IDAP REPORT

Property:	3 Wakeford Road STRATHFIELD LOT: B DP: 386343 DA2021.89
Proposal:	Demolition of existing structures and construction of a two (2) storey dwelling house with basement level, in-ground swimming pool and associated landscaping works.
Applicant:	Bechara Chan & Associates
Owner:	Northpoint Living Pty Ltd
Date of lodgement:	23 April 2021
Notification period:	5 May 2021 to 19 May 2021
Submissions received:	NIL
Assessment officer:	Gary Choice
Estimated cost of works:	\$1,426,072.00
Zoning:	R2-Low Density Residential - SLEP 2012
RECOMMENDATION OF OFFICER:	APPROVAL

Figure 10: Proposed driveway ramp profile

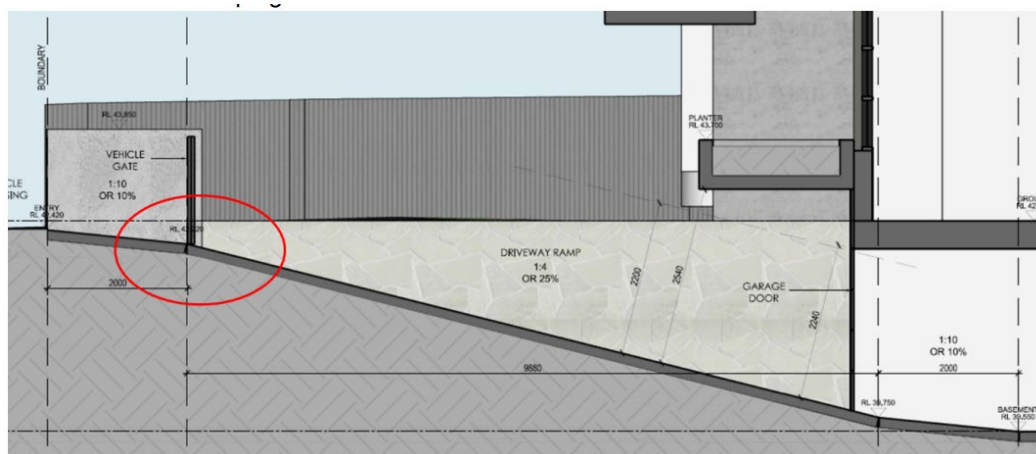
- The driveway profile shows a summit grade change of 15% (circled in red below) which would result in vehicle scraping.
- The proposed basement is not fully contained within the ground floor dwelling footprint
- Rear first floor balcony presents visual privacy impacts to adjoining east property.

The proposed development has been assessed by Council's Traffic Manager whom has identified that the driveway profile shows a summit grade change of 15% (**Figure 10** circled in red below) which would result in vehicle scraping.

Appropriate conditions are imposed for an amended driveway profile design to be provided prior to the issue of any Construction Certificate by increasing the grade of the first 2m section to 1 in 8 to achieve a maximum allowed summit change of 12.5 percent as per AS/ANZ2890.1. The maximum grade for the remaining domestic driveway shall not exceed 25% whilst the minimum headroom of 2.2 metres is to be maintained. Any adjustments must be illustrated on the plans lodged with the application for the Construction Certificate.

- i) Basement Plan shall be amended so that the entire basement area is limited to and contain within the footprint of the dwelling at ground level.
- ii) Driveway Ramp Profile shall be amended to achieve a maximum allowed summit as per AS/ANZ2890.1.
